ELECTRICAL ADDENDUM No. 2

PROJECT NAME: Antigonish County Municipal Building Electrical Service Upgrade & Emergency Generator
DATE: JAN 25, 2023

1 LEAN-TO ELECTRICAL ROOM CONSTRUCTION
ESK-1 NTS

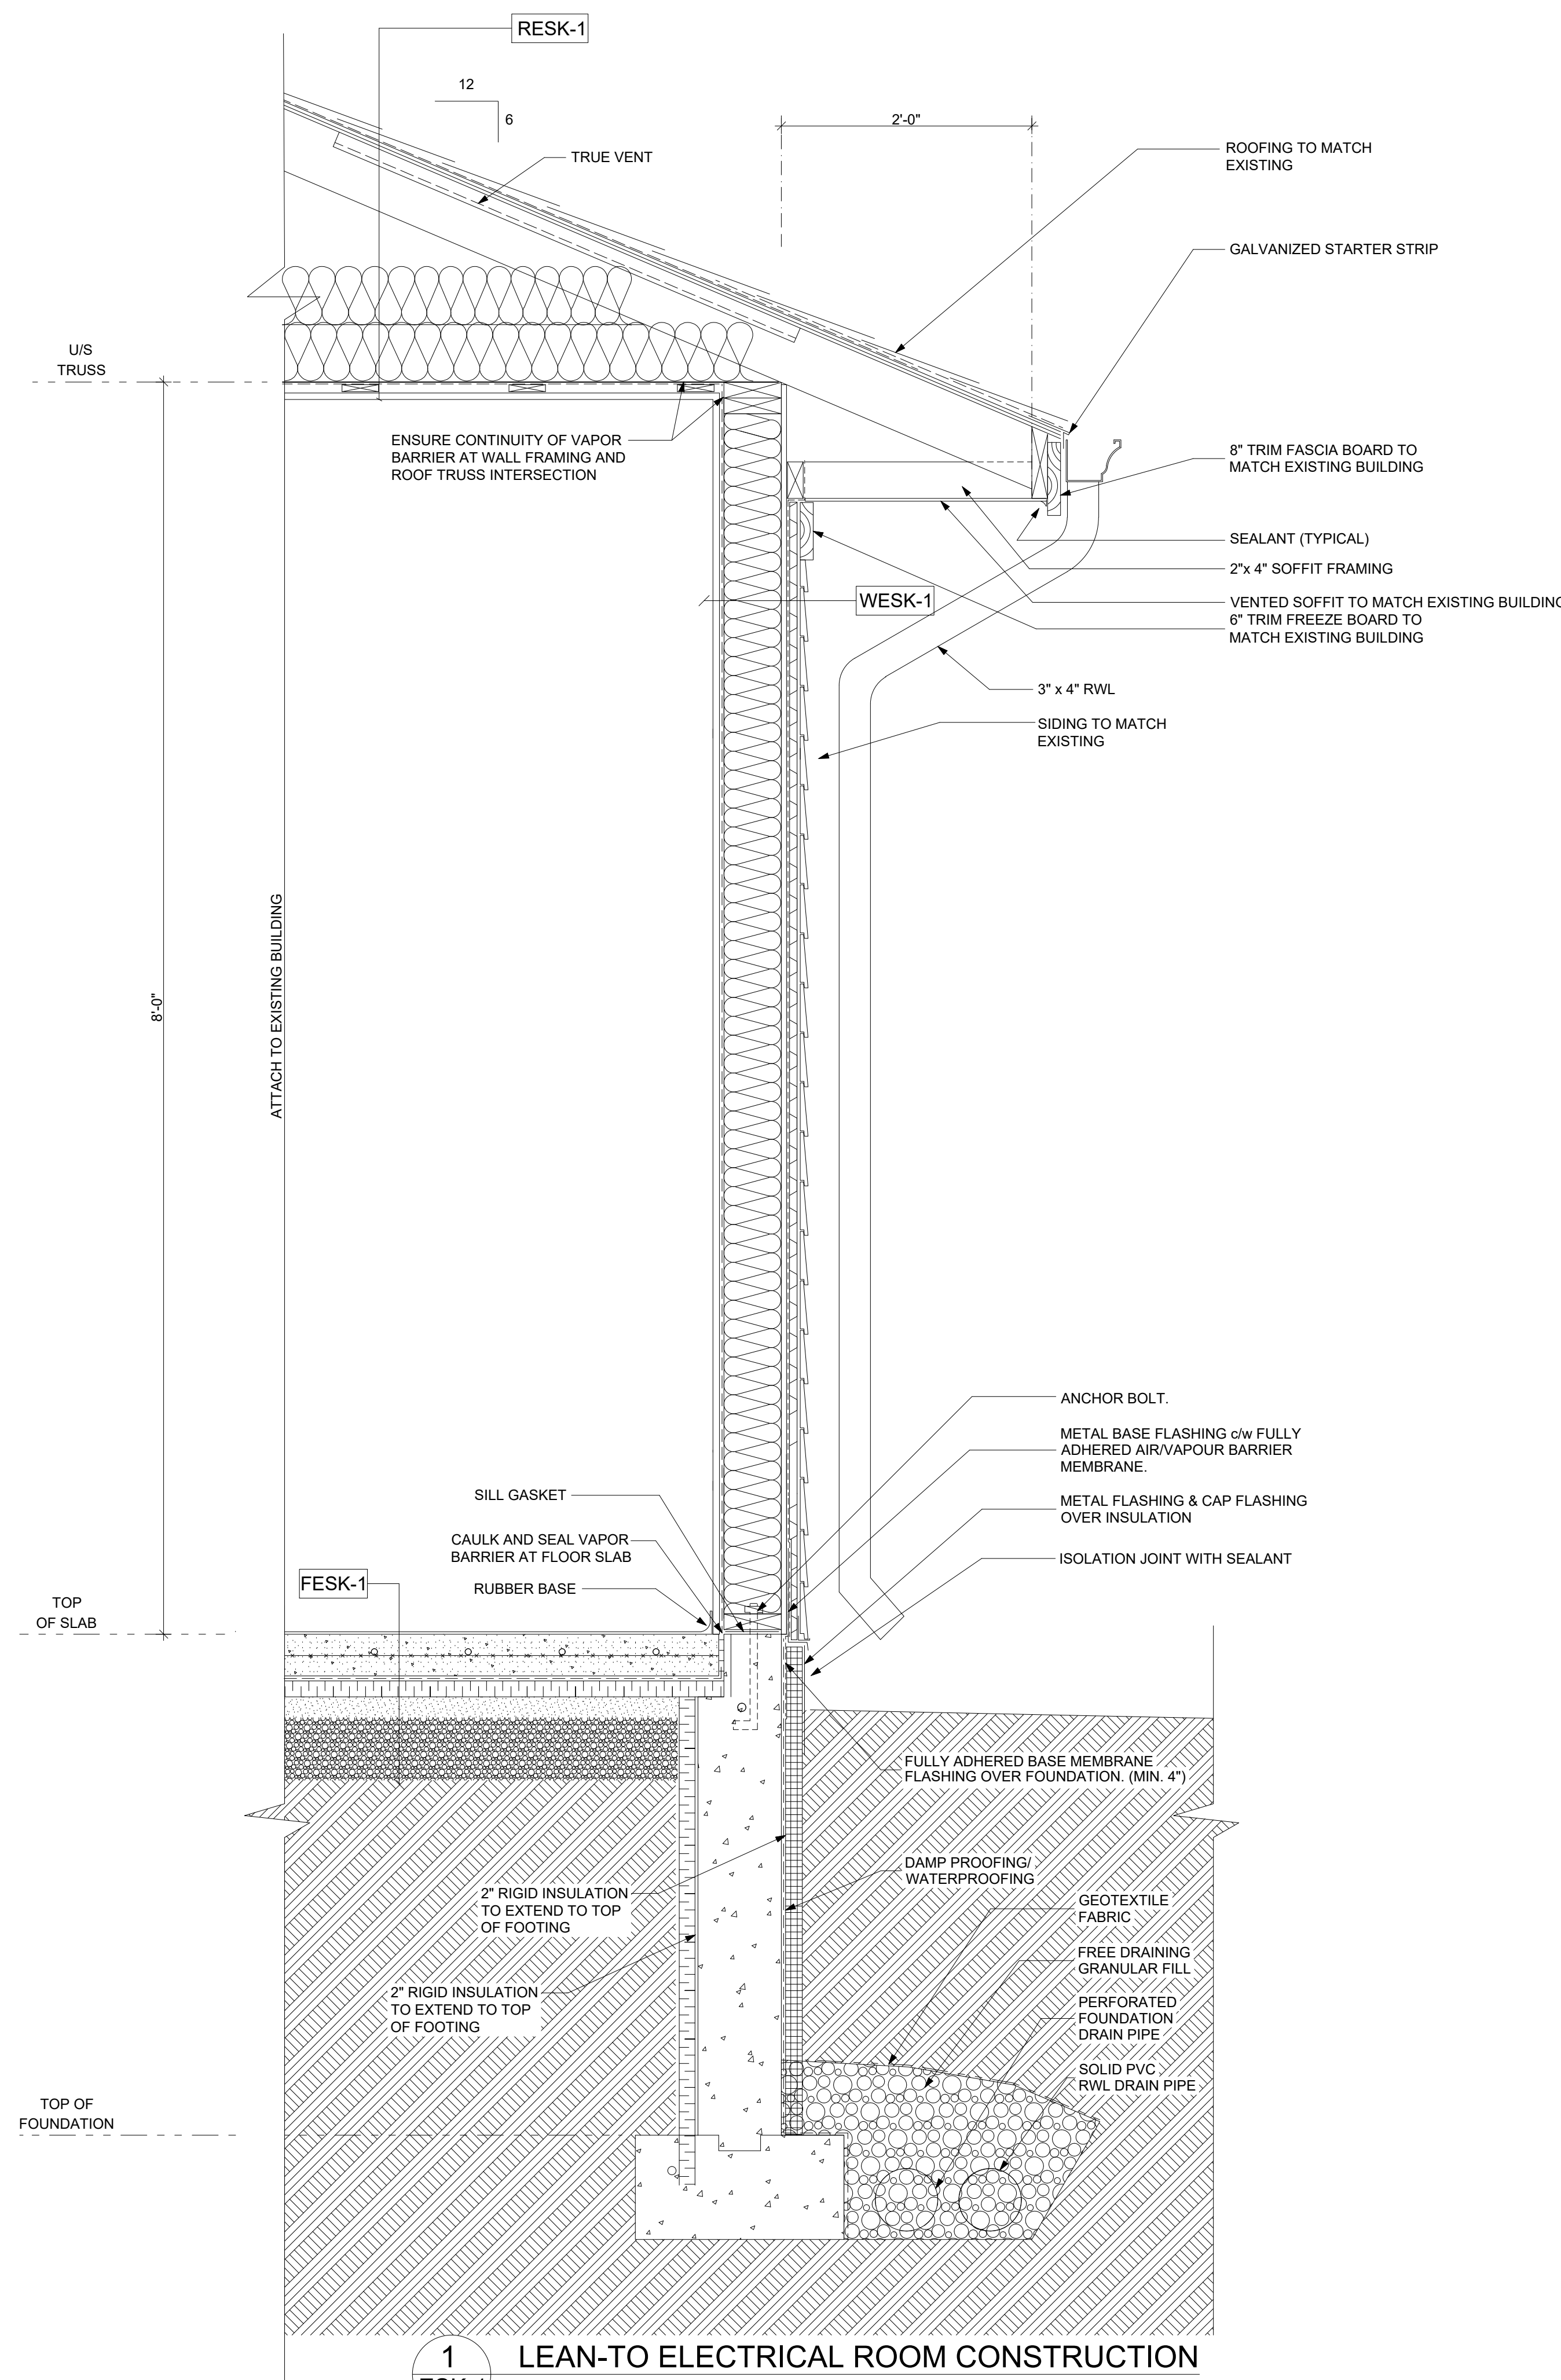
- .5 Detail 3 – This contractor shall be responsible for the construction of the new lean-to electrical room as per the attached the ESK-1 and they are to meet all requirements of the National

Building Code of Canada and Nova Scotia Building Code. Siding and roofing to match existing building. Door to be 36" wide insulated steel door. All work is to be done by certified trades qualified to do this work in the Province of Nova Scotia.

- RESK-1 EXTERIOR ROOF ASSEMBLY**
- 25 YR WARRANTY ASPHALT ROOFING SHINGLES c/w STARTER STRIP
 - # 15 lb ROOFING FELT
 - FULLY ADHERED RUBBERIZED ASPHALT MEMBRANE AT VALLEYS, RIDGES, ETC.
 - 1/2" SUPER ROOF OSB SHEATHING W/ H-CLIPS
 - PRE-ENGINEERED ROOF TRUSSES @ 24" o.c.
 - R-40 BATT INSULATION
 - 1X4 WOOD STRAPPING @ 16" O.C.
 - 6 MIL POLYETHYLENE VAPOUR BARRIER. TAPE, CAULK AND SEAL.
 - 5/8" TYPE 'X' GWB CEILING THROUGHOUT

- FESK-1 FLOOR ASSEMBLY (SLAB)**
- 4" CONCRETE SLAB c/w CONTROL JOINTS
 - WIRE MESH REINFORCING
 - 2" EPS INSULATION
 - 10 MIL POLY V.B.
 - 2" (MAX.) LEVELLING SAND OR PEA GRAVEL AS REQUIRED
 - 6" TYPE 1 GRANULAR
 - COMPACTED SUBGRADE

- WESK-1 EXTERIOR WALL ASSEMBLY**
- FIBER CEMENT BOARD CLADDING & TRIMS (INSTALL AS PER MANUFACTURERS INSTRUCTIONS)
 - EXTRUDED POLYSTYRENE RIGID INSULATION BOARD R-5
 - 1" x 3" PRESSURE TREATED VERTICAL WOOD STRAPPING AT 12" O.C.
 - SELF ADHERED WATER-RESISTIVE AIR BARRIER
 - 1/2" STANDARD GRADE PLYWOOD SHEATHING
 - 2" x 6" WOOD STUD FRAMING AT 16" O.C.
 - GLASS-FIBRE THERMAL BATT INSULATION R-23
 - 6 MIL. POLYETHYLENE FILM VAPOUR BARRIER
 - 5/8" STANDARD GYPSUM WALL BOARD, TAPE AND FILL

NOTE:
ON WALLS THAT EXTEND TO U/S OF ROOF TRUSSES, PROVIDE FIRE STOP CAULKING AND NOISE SEAL CAULK AS REQUIRED.
PROVIDE INSULATED STEEL DOOR WITH LATCH TO MATCH EXISTING HARDWARE AND KEYING
